BUILDING CODE OF AUSTRALIA (BCA) COMPLIANCE

ASSESSMENT REPORT

| Project Address | 2 DELMAR PARADE DEE WHY, NSW 2099 |
| Report No. | 19/055 |

Basement levels 1 & 2

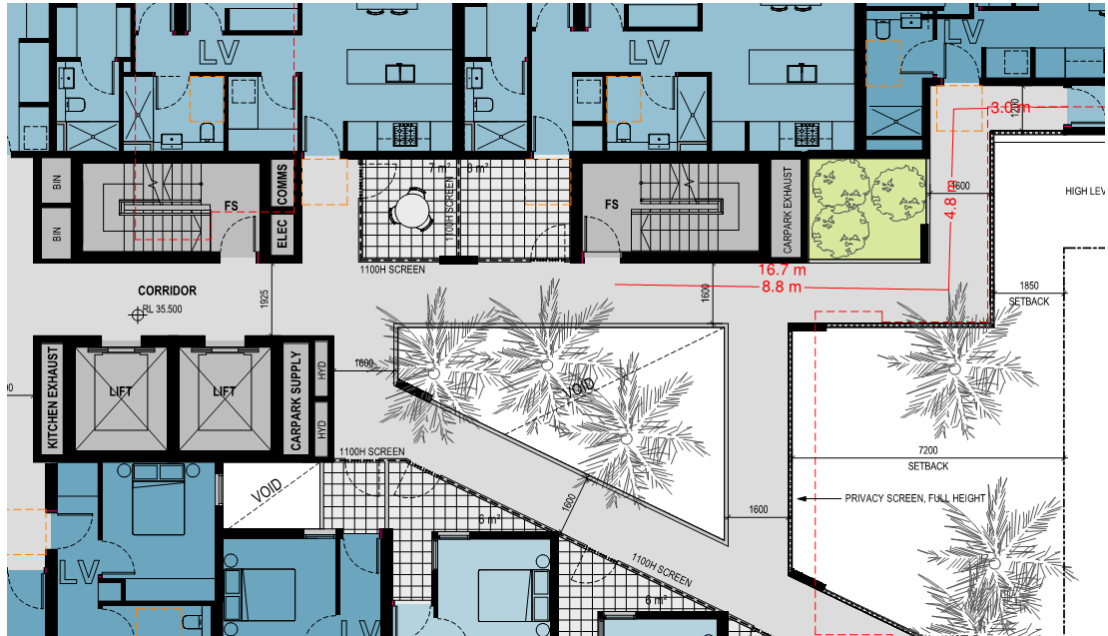
- Travel distances exceed 20m to a point of choice between the two exits provided

Level one

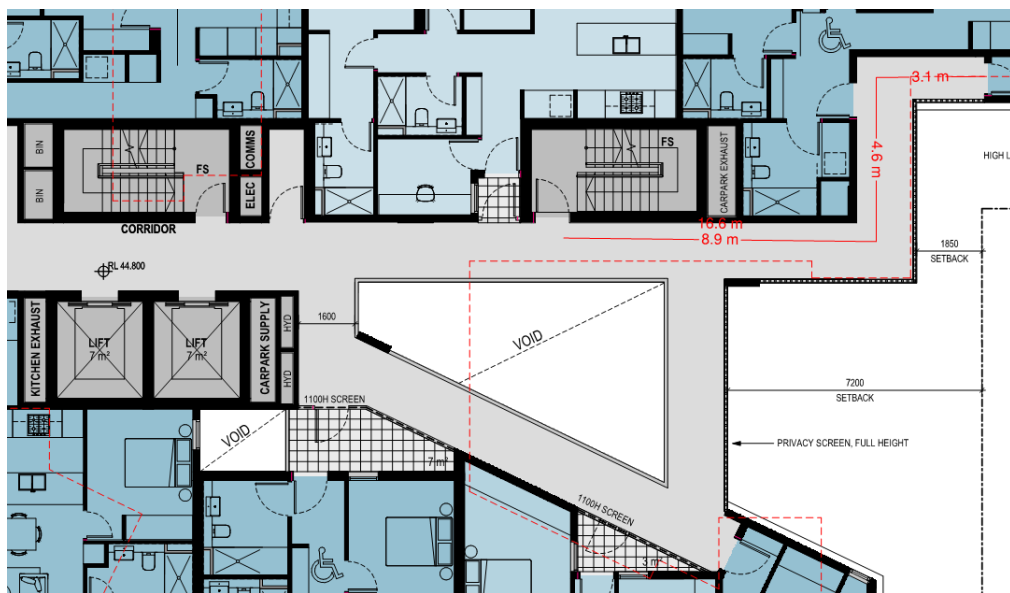
- Travel distances to a point of choice between the two exits provided well exceeds the maximum permissible 6m distance. Some units are required to travel up to 25m to the point of choice, which still exceeds the 12m limit if the permitted concession applies under Specification E1.5a Clause 3
- Travel distances from the communal courtyard to the closest exit also well exceeds the maximum permissible 20m
